10/542,611

Office Action Summary	Application No. 10/542,611	Applicant(s) SHINOI ET AL.	
	Examiner NADER BOLOURCHI	Art Unit 2611

DETAILED ACTION

FIG.3

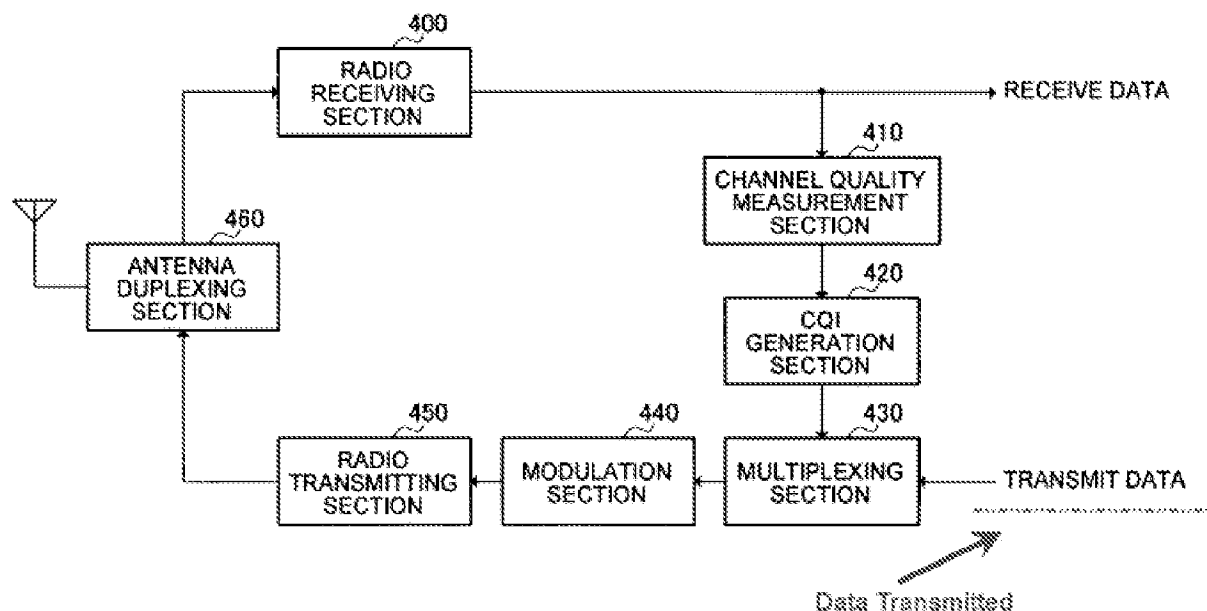
Claims 23 (lines 3-8) and 33 (lines 4-9) use the phrase "packet" which is vague and unclear. It is not clear what term "packet" is referring to.

Phrase "packet", used in the "Background Art" section of the Applicant's Specification, for data to refer to the data transmitted for a fixed period of time (emphasis added):

Therefore, it should be equivalent to "transmit data" shown in Fig. 3 (emphasis added):

FIG.2

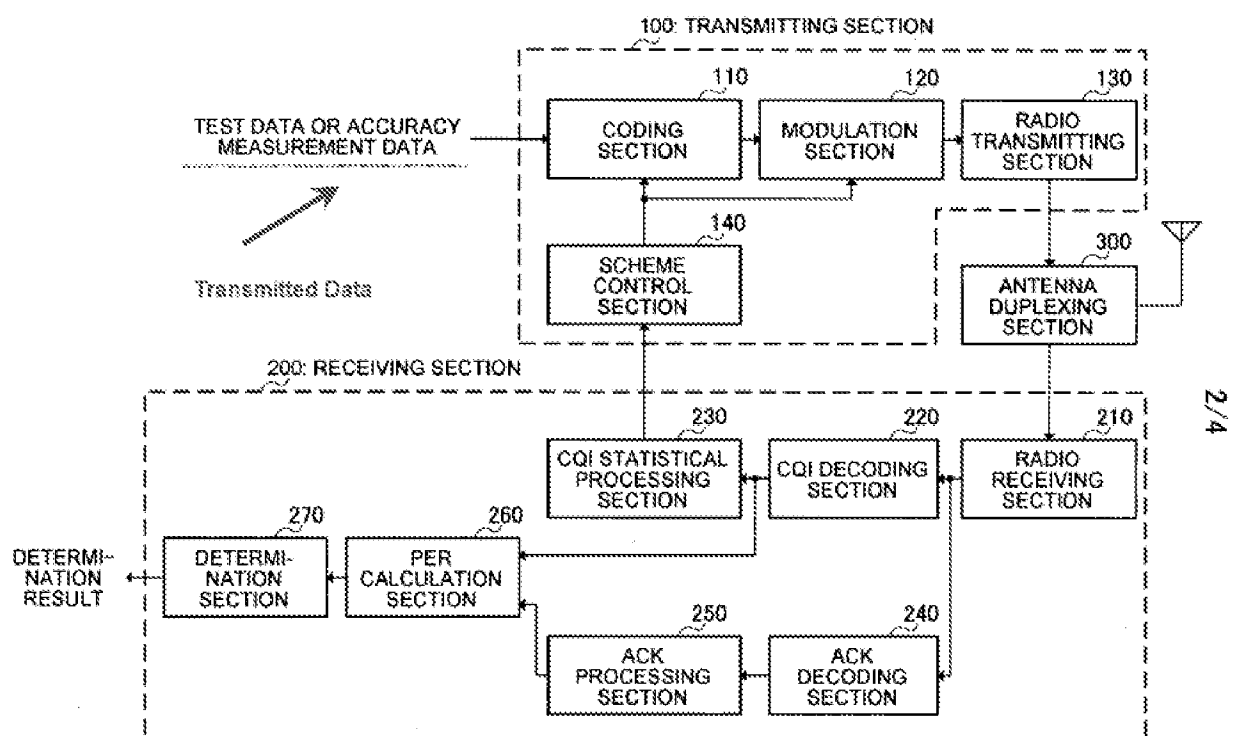
Furthermore, Fig. 2 clearly indicates that the data transmitted could be either "test data" or "accuracy measurement data", which as discussed above, one should conclude that "packet" is a data equivalent to either "test data" or "accuracy measurement data" (emphasis added)

Which is in contradiction with the specification disclosing that the data transmitted must be "test data and accuracy measurement data", which makes one to conclude that "packet" is a data equivalent to "test data and accuracy measurement data" (emphasis added)

However, claims 23 (lines 3-8) and 33 (lines 4-9) use the phrase "packet" for data to refer only to "accuracy measurement data", which makes the term "packet" vague and indefinite.
